Subject: **COLOR INVERSION**

Model: **BKM-2085-14, BKM-2085-20**

Serial No: **2,000,001–2,000,655 (BKM-2085-14)**
2,000,001–2,000,575 (BKM-2085-20)

Figure 1

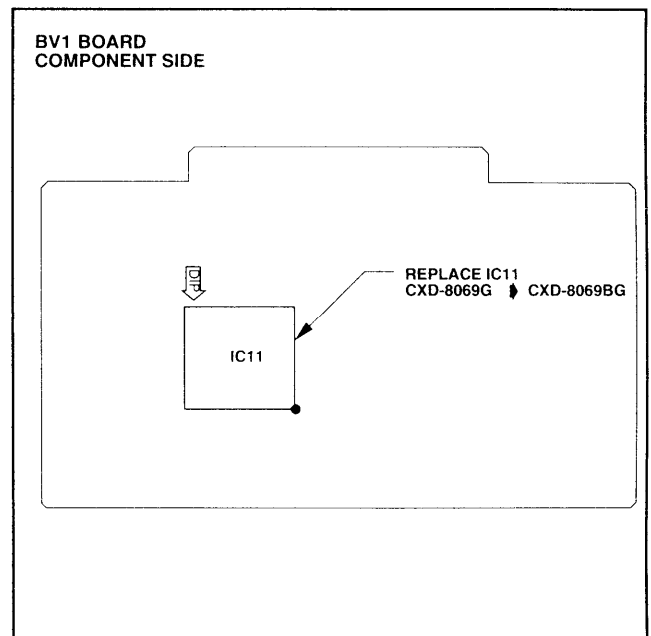
Color inversion may occur if nonsynchronized signals are switched and input through the serial digital video decoder (IC11) on the BV1 board. If this occurs, replace IC11 (CXD-8069G) on the BV1 board with upgraded IC type CXD-8069BG. (See Figure 1.)

NOTE: If a jumper wire is installed between pins 32 and 62 of IC11 (CXD-8069G) on the BV1 board, remove it when replacing IC11; do not reinstall it.

Part No.	Description	Qty.
8-759-164-99	CXD-8069BG (IC11/BV1)	1
